ADDENDUM NO. TWO  
NCSB -FBMS

To the Plans and Specifications for:  
Nassau County School Board – Project No. 98110-031  
Fernandina Beach Middle School Kitchen / Dining Remodeling and Campus  
Renovations/Enhancements

Date: October 16, 2018

AS103

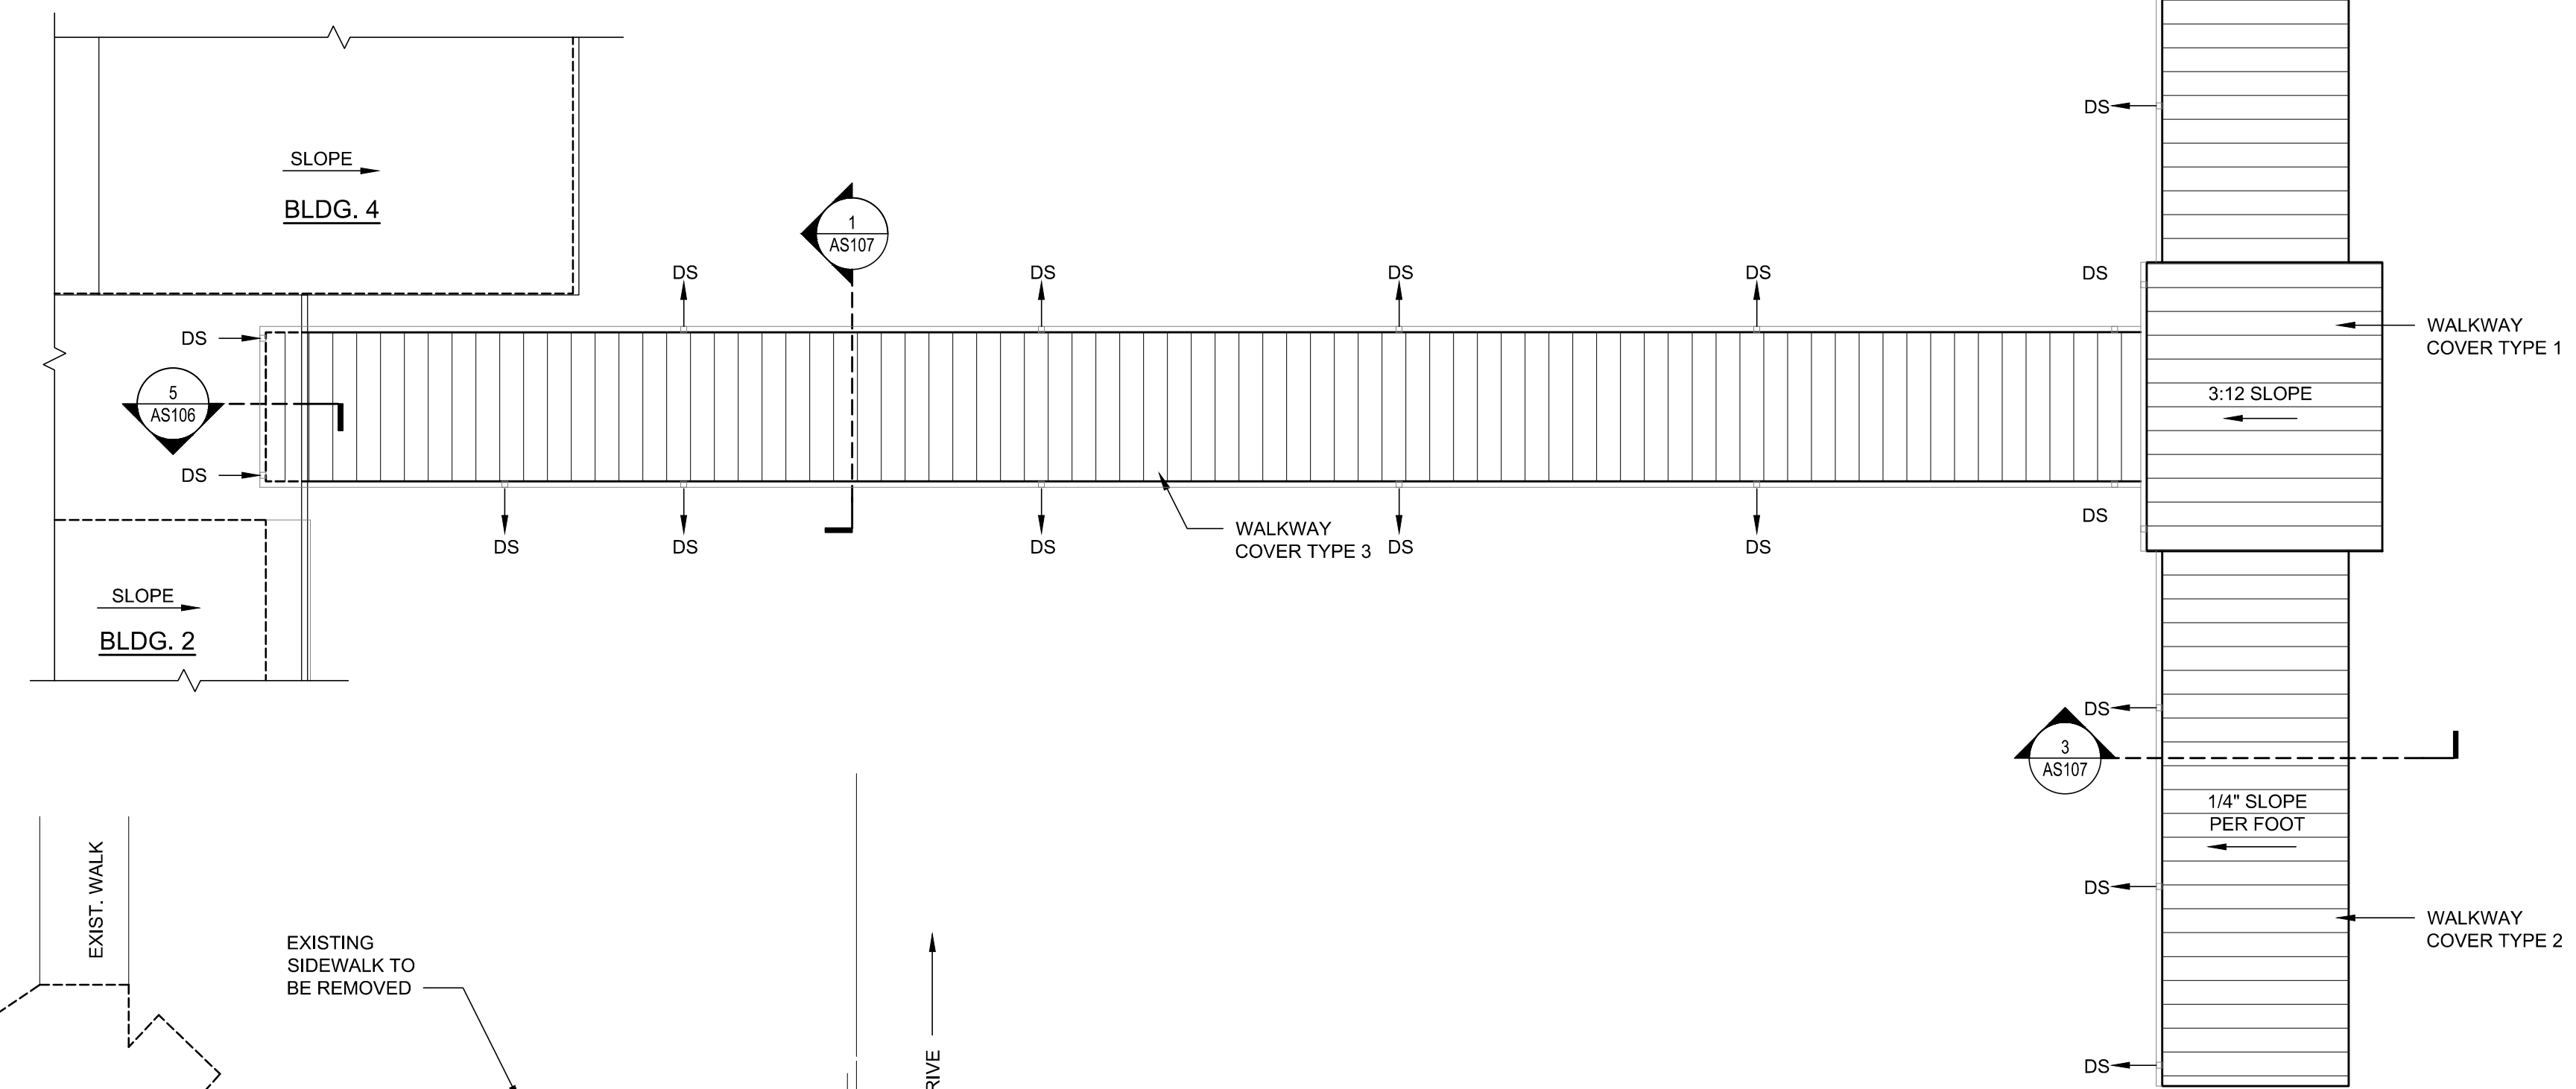
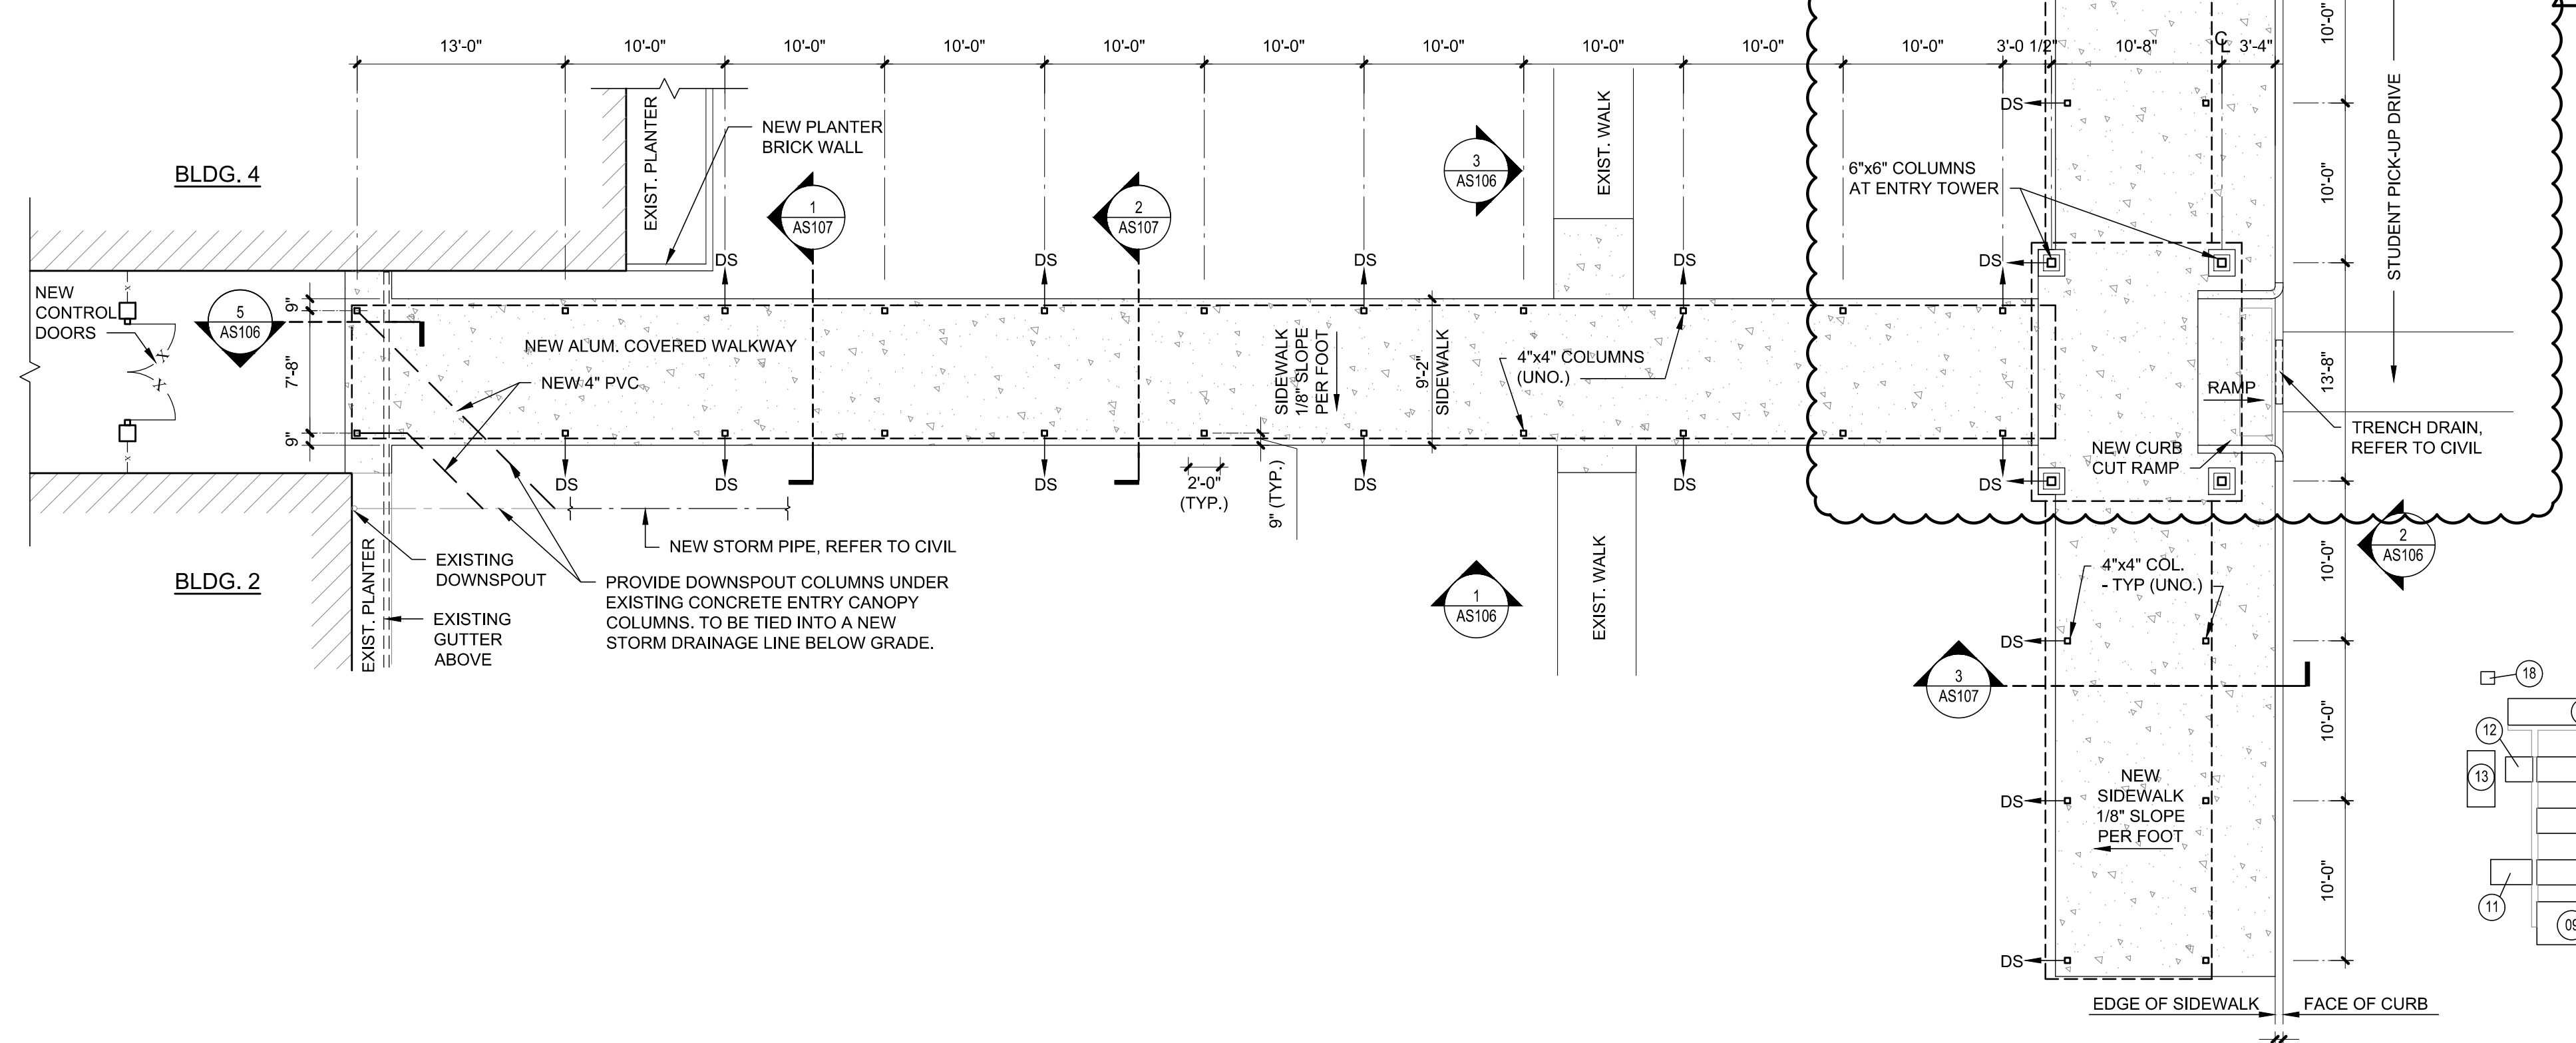
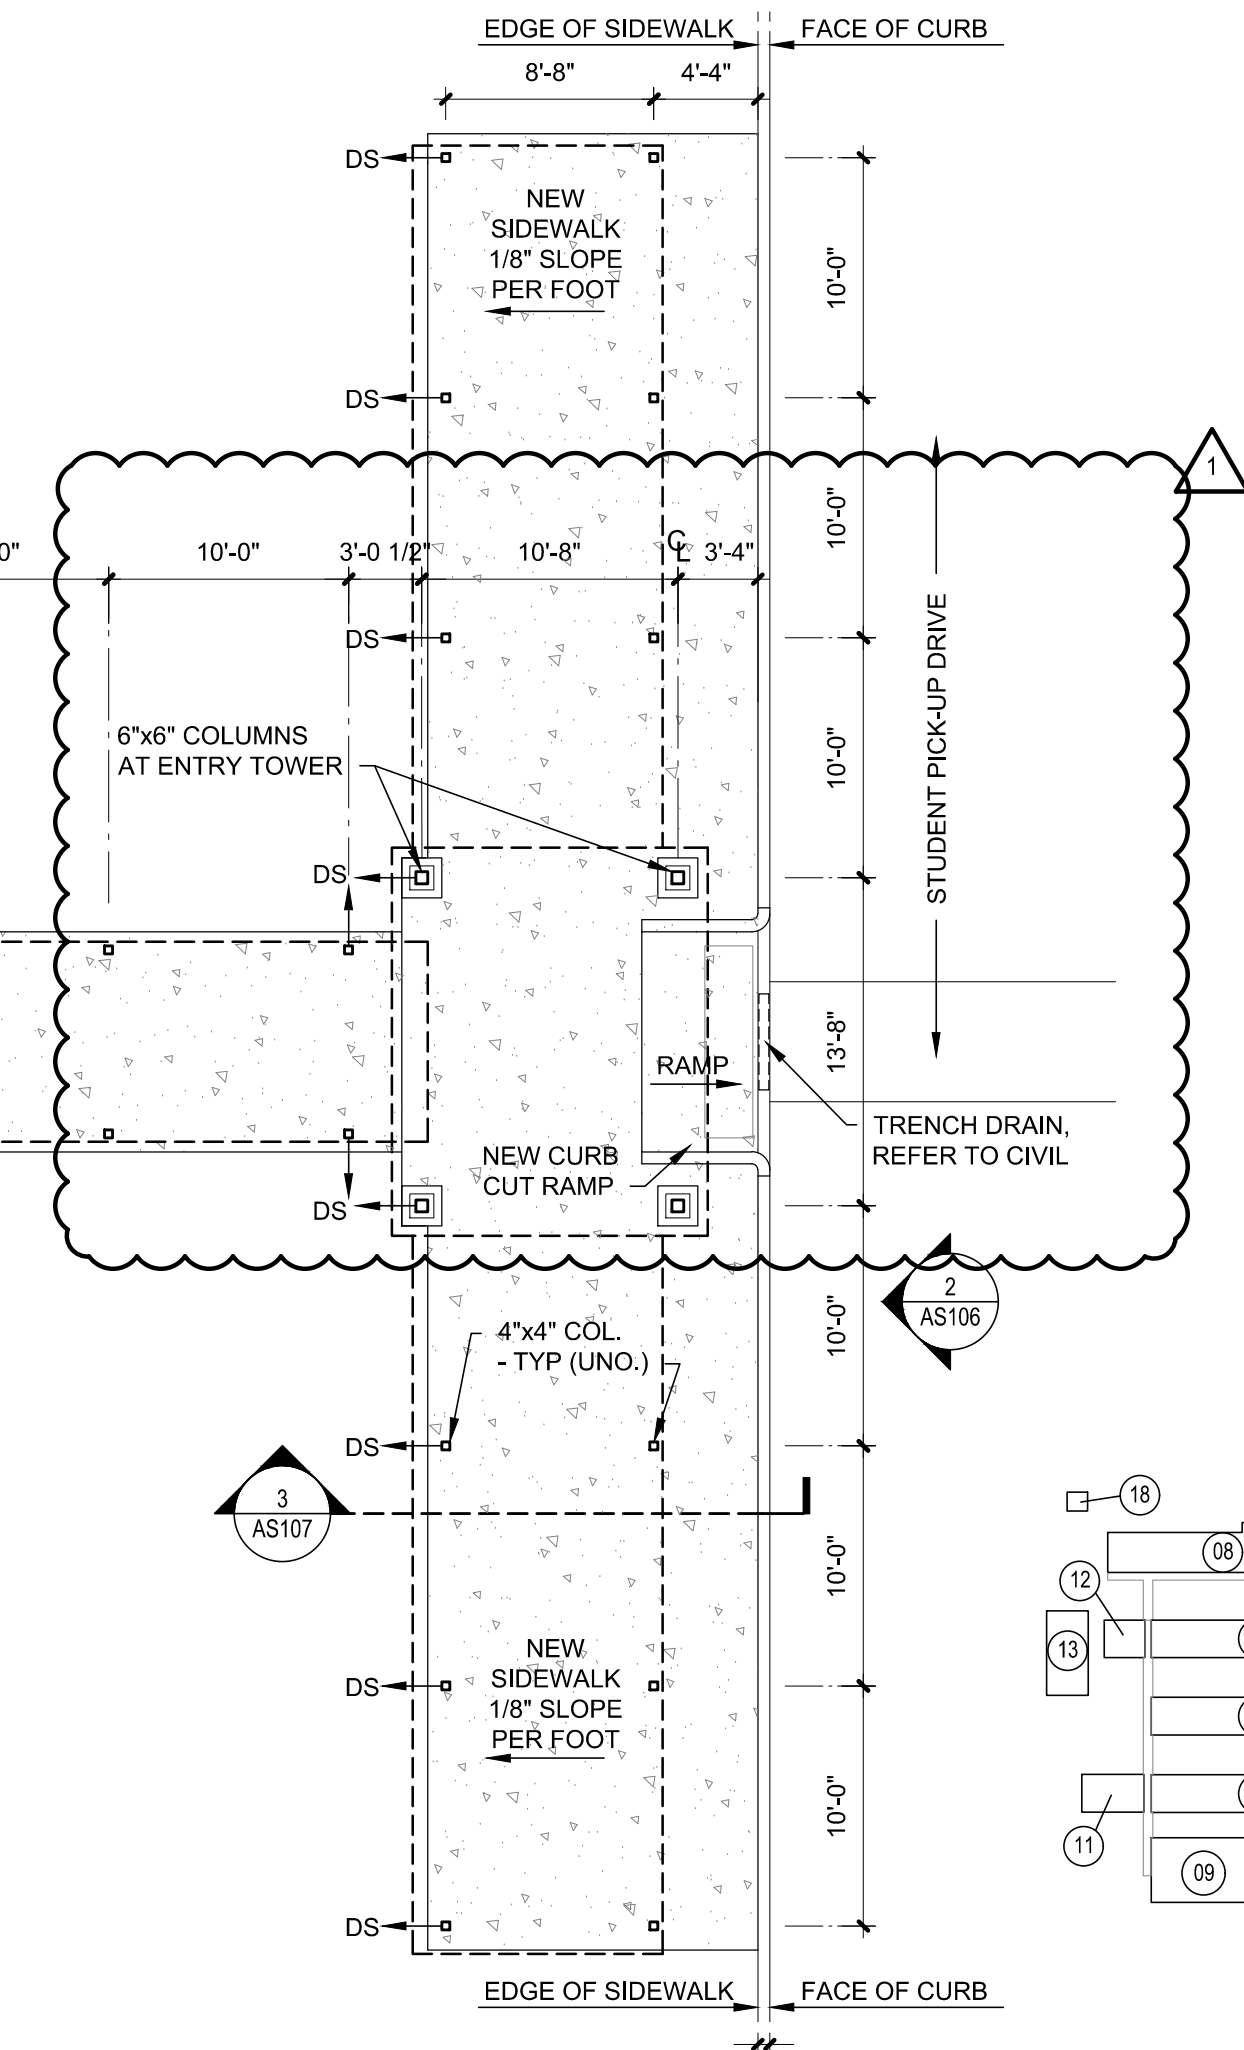
Sheet AS102. Add the following note at the sidewalk for the new covered walkway. “Existing benches shall be relocated on-site or discarded as directed by the school Principal.”
